**Marion County
Board of County Commissioners**

**PLANNING & ZONING SECTION
STAFF REPORT**

P&ZC Date: 04/28/2025	BCC Date: 05/19/2025
Case Number	250507ZP
CDP-AR	32481
Type of Case	Rezoning from Single-Family Dwelling (R-1) to Planned Unit Development (PUD) for a maximum of 151 multi-family dwelling units.
Owner	Lake Louise, LLC.
Applicant/Agent(s)	Kimley-Horn & Associates, Inc.
Street Address / Site Location	No site address
Parcel Number	3060-007-004, 3060-004-001
Property Size	±9.51 acres
Future Land Use	Urban Residential (UR)
Zoning Classification	Single-Family Dwelling (R-1)
Overlay Zone/Scenic Area	Urban Growth Boundary (UGB), Primary Springs Protection Overlay Zone (PSPOZ)
Staff Recommendation	Approval with conditions
P&ZC Recommendation	No Recommendation (3-3 vote)
Project Planner	Kathleen Brugnoli
Historic/Related Case(s)	190711SU: Hay Production in R-1 – Approved; 22-S08: Small Scale Map Amendment from Medium Residential (MR) to Urban Residential (UR) – Approved.

Figure 7
Lake Louise Site Plan

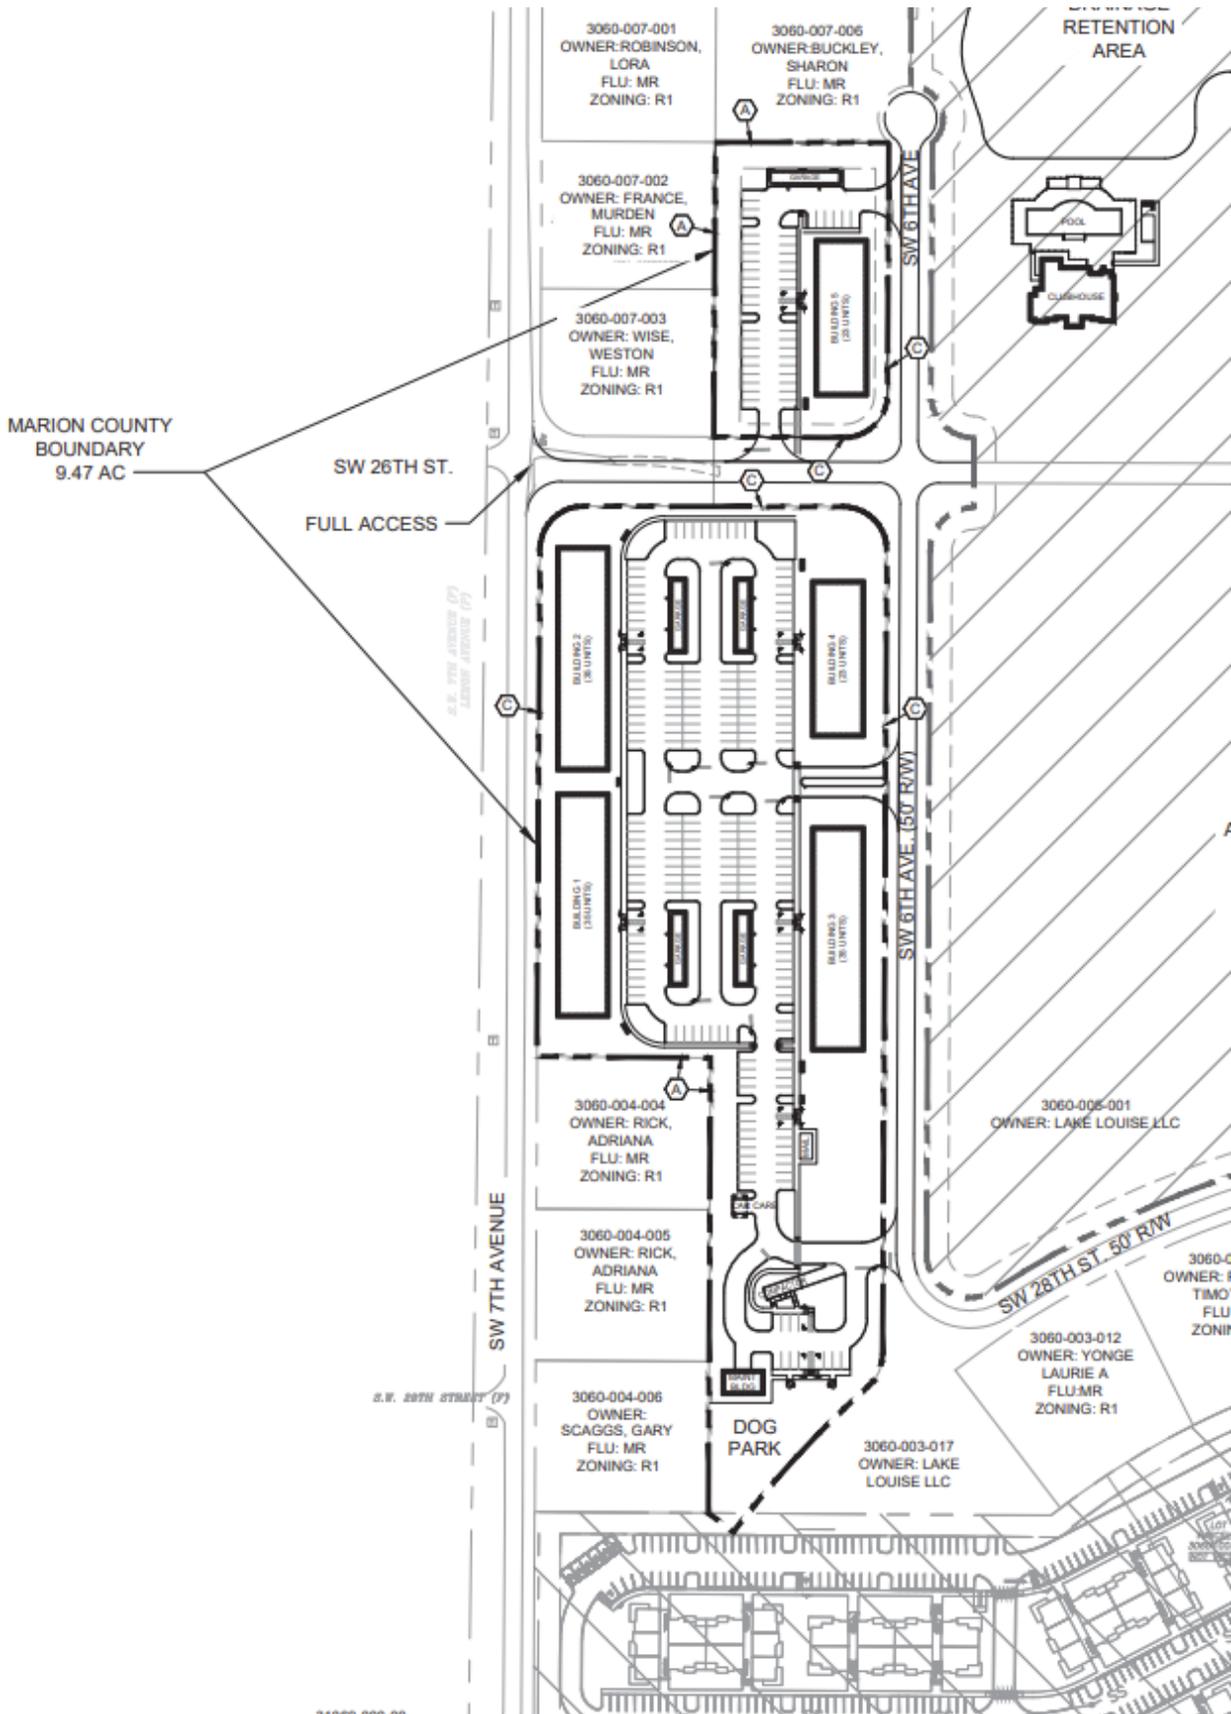
The plan proposed includes three 35-unit structures and two 23-unit structures. The maximum building height provided would be 40' with a required minimum 30' separation between the buildings.

Analysis: Stormwater was not addressed with the site plan but staff was told the intent is for stormwater to be diverted to the eastern (City) portion of the project where a drainage retention area is proposed. As such, staff is imposing the condition provided below. If met, the application is **consistent** with this section. If this condition is removed, the application is **not consistent** with this section.

Analysis: The PUD Plan proposes the sites various setbacks, height, and floor area ratio amounts in a table format but does not provide a typical illustration showing these. The PUD is **not consistent** with this section

Analysis: The PUD plan states the minimum 20% open space will be provided but does not give detailed figures or list the areas being designated for open space on the site plan. The application is currently **not consistent** with this section of the LDC as there are no figures provided to confirm the minimum open space requirement.

4. The PUD shall be limited to a maximum of 151 multi-family units.
5. The PUD shall be developed consistent with the PUD plan provided.
6. A property owner's association OR the developer must care for and maintain all common areas used by residents of the subdivision as well as buffers, stormwater, and any other forms of infrastructure within the subdivision.
7. Sidewalk to be provided internally as shown in the PUD site plan.
8. Sidewalks, as required by Traffic, shall be developed or a fee in lieu of sidewalks to be paid.
9. There shall be no construction or development of this PUD until adjacent PUD development is completed and stormwater systems are installed with

11. The PUD must meet the LDC requirement of a minimum of 20% improved open space.
12. The final PUD master plan must be brought back and heard by the Board of County Commissioners for final approval.
